REVIEW OF FOUNDATION REPORT BY
E. M. PETG ASSOC., LTD., and
PRELIMINARY PLANS -
Bridge Office Ref. BA 1349.

Re: Proposed New Bridge at Bear Creek,
Lots 15/16, Con. XIV, Sombra Twp.,
Lambton Co., District # 1

RE: Lambton County Bridge
Sombra Twp., Lot 16, Con. 14
Bear Creek N.E. of Wilkesport
Mun. Dist. #1 - SW621
W.O. 360-cl-139

CHANNEL IMPROVEMENT PRELIMINARY PLAN	
J. J. O'CONNELL & CASE LIMITED CONSULTING CIVIL ENGINEERS CHATHAM — ONTARIO	
BEAR CREEK BRIDGE OVER BEAR CREEK TOWNSHIP OF SOMERSET COUNTY OF LANARK	
SCALE 1" = 50'	DATE JAN. 31, 1960
CHECKED BY 277	62109-3

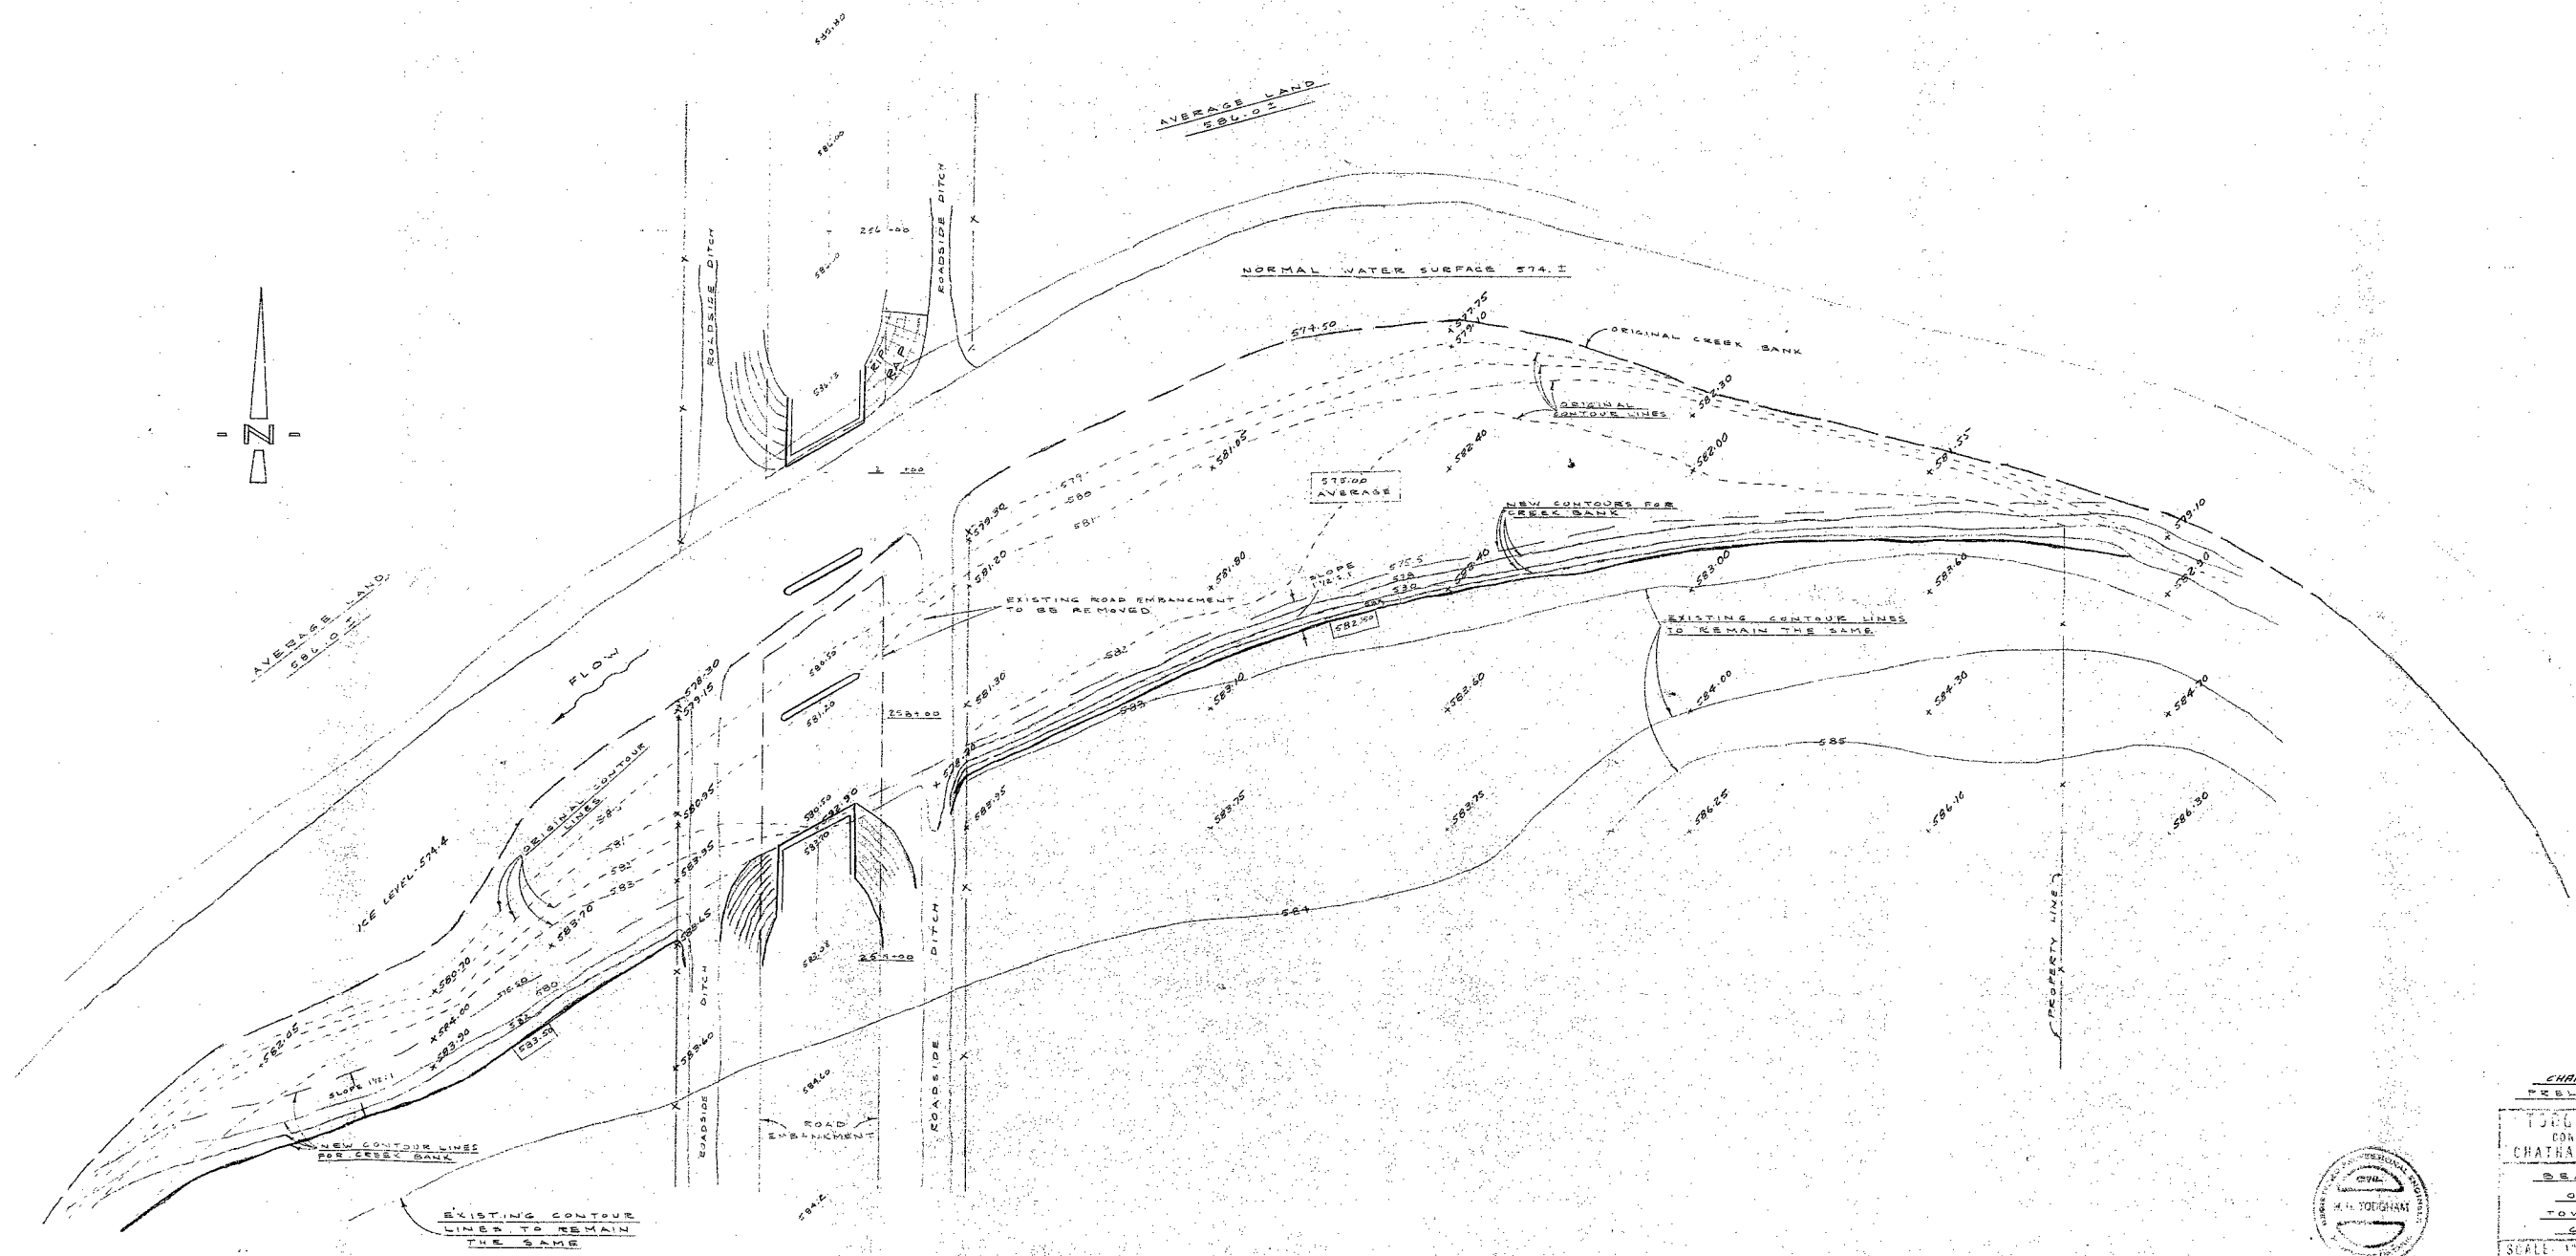
With regard to the location of the bridge relative to the channel, the principle of opening out the channel on the south bank is sound, since the bulk of the flood overflow crosses the south flood plain. However, in view of the erosion of the north river bank at and upstream from the proposed bridge it is recommended that the north abutment be moved slightly further back, to about 10' north of the position shown on drawing 62109-3.
